Model 064, 066 Chainsaws – Series 1122

1. Ignition Systems (Flywheel, Ignition Module)

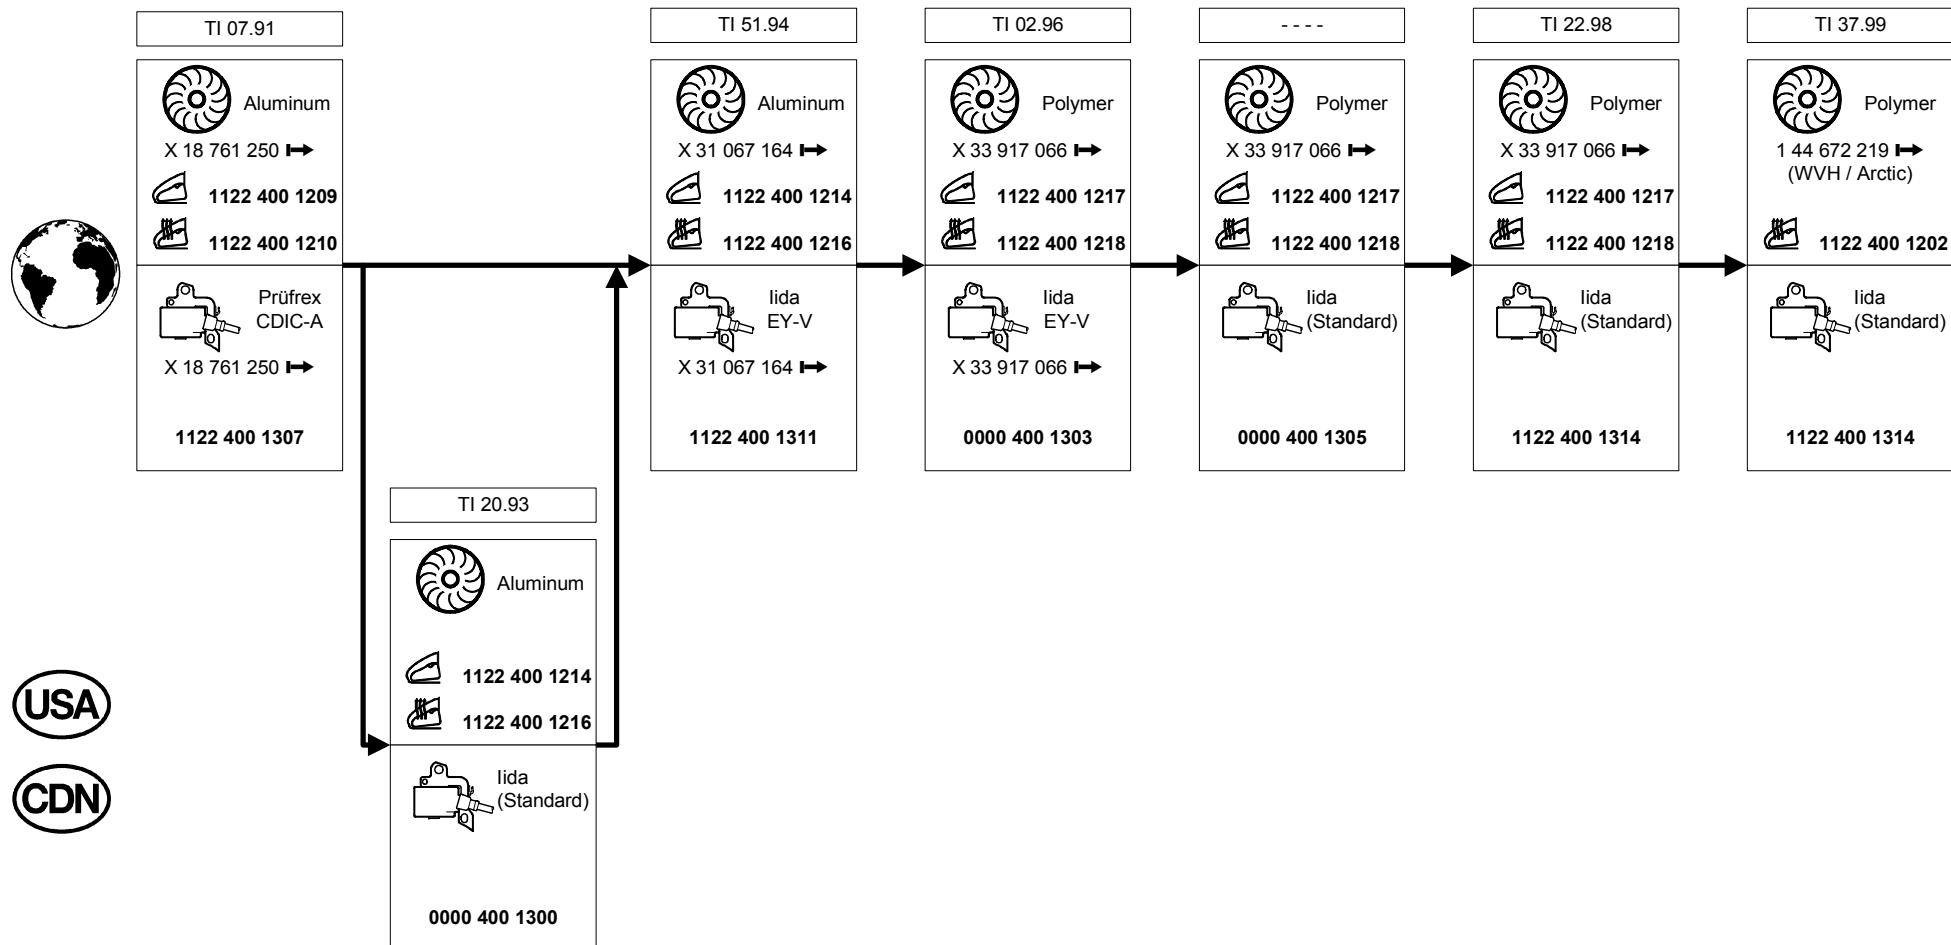
Constant developments have resulted in several interchangeable and non-interchangeable modifications of the ignition system (flywheel and ignition module) on models 064 and 066.

The following chart shows all the relevant changes in chronological order as well as the numbers of the Technical Information bulletins in which the changes are described.

TI 43.86	TI 10.89	TI 51.94	TI 22.98
 Aluminum  1122 400 1201  1122 400 1206	 Aluminum X 18 761 250 ➡  1122 400 1203  1122 400 1207	 Aluminum X 18 761 250 ➡  1122 400 1203  1122 400 1207	 Aluminum X 18 761 250 ➡  1122 400 1203  1122 400 1207
 Bosch E1-V 1122 400 1300	 Prüfref CDIC X 18 761 250 ➡ 1122 400 1303	 Iida EY-V X 31 067 164 ➡ 1122 400 1311	 Iida (Standard) X 31 067 164 ➡ 0000 400 1300
